# HISTORIC AND DESIGN REVIEW COMMISSION

July 19, 2023

**HDRC CASE NO:** 2023-227  
**ADDRESS:** 217 VANCE ST  
**LEGAL DESCRIPTION:** NCB 733 BLK 5 LOT 15, & E IRR 8 FT OF 14  
**ZONING:** R-6, H  
**CITY COUNCIL DIST.:** 1  
**DISTRICT:** Lavaca Historic District  
**APPLICANT:** Vicki Yuan  
**OWNER:** WALLACE ANNE REYNOLDS  
**TYPE OF WORK:** Demolition of a rear accessory structure and new construction of a 1-story rear accessory structure  
**APPLICATION RECEIVED:** June 05, 2023  
**60-DAY REVIEW:** August 4, 2023  
**CASE MANAGER:** Rachel Rettaliata

1. Demolish the existing 1-story rear carport structure.
2. Construct an approximately 864-square-foot, 1-story rear accessory structure.

BUILDING ELEVATIONS  
SCALE: 1/4" = 1'-0"

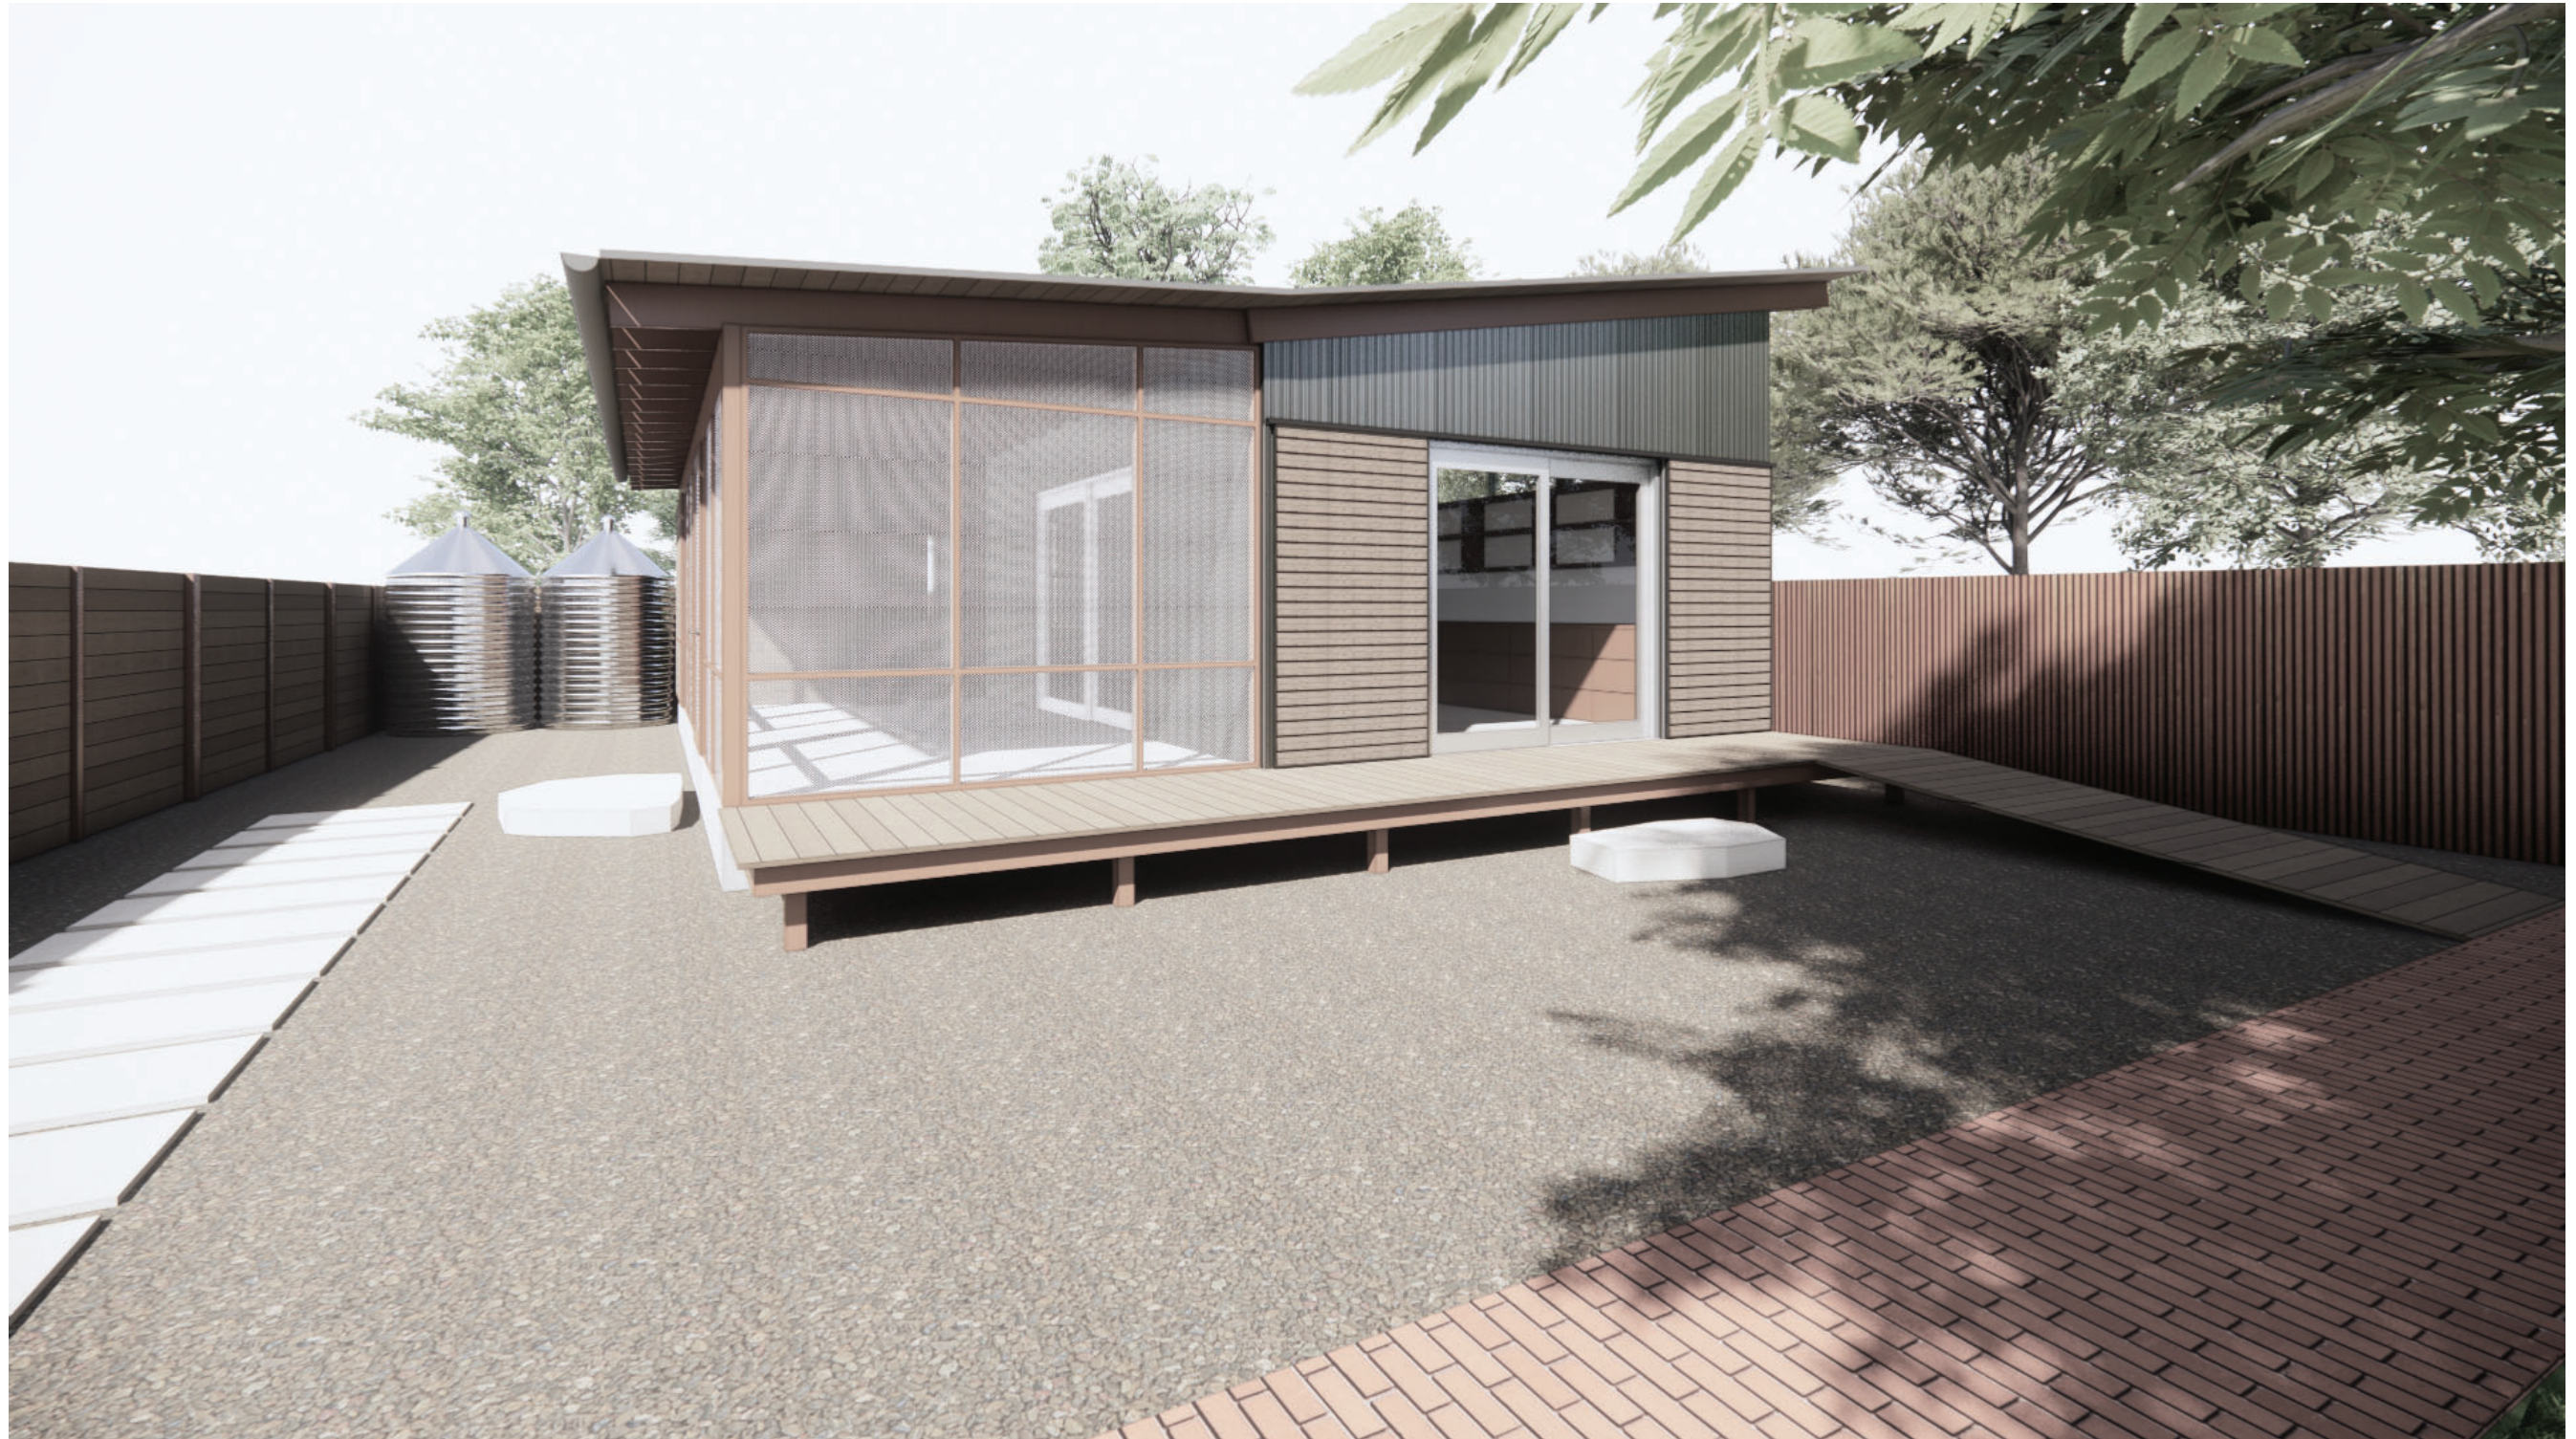
- 2b. SCALE & MASS – The applicant has proposed to construct a 1-story rear accessory structure. The applicant has not provided total height information at this time; however, the structure will feature a height of approximately 14 feet, not including the roof, at the highest point on the north elevation. The Historic Design Guidelines state that new construction should be consistent with the height and overall scale of nearby historic buildings and rear accessory structures. Staff finds that the applicant

- 2d. ROOF FORM – The applicant has proposed a shed roof form that is similar to a butterfly roof form with the highest point of the roof at the north elevation, sloping to the south side of the structure. Guideline 2.B.i for New Construction states that new construction should incorporate roof forms – pitch, overhangs, and orientation – that are consistent with those predominantly found on the block. The roof form on the existing rear accessory structure is a side gable roof form, the primary structure features a hip roof form, and the primary structure at 215 Vance features a front gable roof form. Primary and rear accessory structures on this block feature hip, front gable, and side gable roof forms. Staff finds that the applicant should submit a line-of-sight study showing that the rear accessory structure will not be visible from the public right-of-way.

- 2e. MATERIALS – The applicant has proposed a rear accessory structure that features a standing seam metal paint grip roof with wood decking at the roof eaves and exposed wood roof joists, corrugated metal paint grip siding, reclaimed wood accents, western red cedar screened porch framing, and bronze insect screening. Guideline 3.A.i for New Construction states that new construction should feature materials that complement the type, color, and texture of materials traditionally found in the district. Materials should not be so dissimilar as to distract from the historic interpretation of the district. For example, corrugated metal siding would not be appropriate for a new structure in a district comprised of homes with wood siding. Guideline 3.A.v for New Construction states that vinyl siding, plastic, or corrugated metal sheeting should not be used. Contemporary materials not traditionally used in the district, such as brick or simulated stone veneer and Hardie Board or other fiberboard siding, may be appropriate for new construction in some locations as long as new materials are visually similar to the traditional material in dimension, finish, and texture. Staff finds the use of corrugated metal siding to be inconsistent with the Guidelines and finds that the applicant should propose an alternate cladding material that complements the type, color, and texture of materials traditionally found in the district or should limit the use of corrugated metal as an accent or secondary material.

- 2f. MATERIALS: DOORS AND WINDOWS – The applicant has proposed to install aluminum windows on the north elevation, an aluminum sliding entry door on the east elevation, a full lite aluminum door on the west elevation, a full lite wood door on the screened porch of the west elevation, a screen door on the south elevation, and a sliding door on the interior of the screened porch on the south elevation. Wood or aluminum-clad wood windows are most appropriate; however, an alternative window material may be proposed, provided that the windows feature an inset of two (2) inches within facades and should feature profiles that are found historically within the immediate vicinity. White manufacturer's color is not allowed, and color selection must be presented to staff. There should be a minimum of two inches in depth between the front face of the window trim and the front face of the top window sash. This must be accomplished by recessing the window sufficiently within the opening or with the installation of additional window trim to add thickness. Window trim must feature traditional dimensions and an architecturally appropriate sill detail. Window track components must be painted to match the window trim or be concealed by a wood window screen set within the opening. Staff finds that the applicant should submit product specifications for the proposed windows and doors to staff for review.

- 2g. RELATIONSHIP OF SOLIDS TO VOIDS – Guideline 2.C.i for New Construction stipulates that new construction should incorporate window and door openings with a similar proportion of wall to window space as typical with nearby historic facades. Windows, doors, porches, entryways, dormers, bays, and pediments shall be considered similar if they are no larger than 25% in size and vary no more than 10% in height to width ratio from adjacent historic facades. Guideline 5.A.iv for New Construction states that window and door openings should be designed to be similar to those found on historic garages or outbuildings in the district or on the principle historic structure in terms of their spacing and proportions. The applicant has proposed to install square fixed and operable windows as a row of clerestory windows on the north elevation. Staff finds that the proposed windows are consistent with the architectural design

- ii. That the applicant submits documentation showing the proposed height and scale in relation to the adjacent primary structures and neighboring rear accessory structures to staff for review and approval prior to the issuance of a Certificate of Appropriateness based on finding 2b.

- iii. That the applicant submits a line-of-sight study showing that the rear accessory structure will not be visible from the public right-of-way to staff for review and approval prior to the issuance of a Certificate of Appropriateness based on finding 2d.

- iv. That the applicant proposes an alternate cladding material that complements the type, color, and texture of materials traditionally found in the district or limits the use of corrugated metal as an accent or secondary material based on finding 2e and submits updated elevation drawings and material specifications to staff for review and approval prior to the issuance of a Certificate of Appropriateness.

- v. That the applicant submits window and door product specifications to staff for review and approval prior to the issuance of a Certificate of Appropriateness based on finding 2f. Wood windows or aluminum-clad windows are most appropriate; however, an alternative window material may be proposed, provided that the window features an inset of two (2) inches within facades and should feature profiles that are found historically within the immediate vicinity. White manufacturer's color is not allowed, and color selection must be presented to staff. There should be a minimum of two inches in depth between the front face of the window trim and the front face of the top window sash. This must be accomplished by recessing the window sufficiently within the opening or with the installation of additional window trim to add thickness. Window trim must feature traditional dimensions and architecturally appropriate sill detail. Window track components must be painted to match the window trim or concealed by a wood window screen set within the opening.
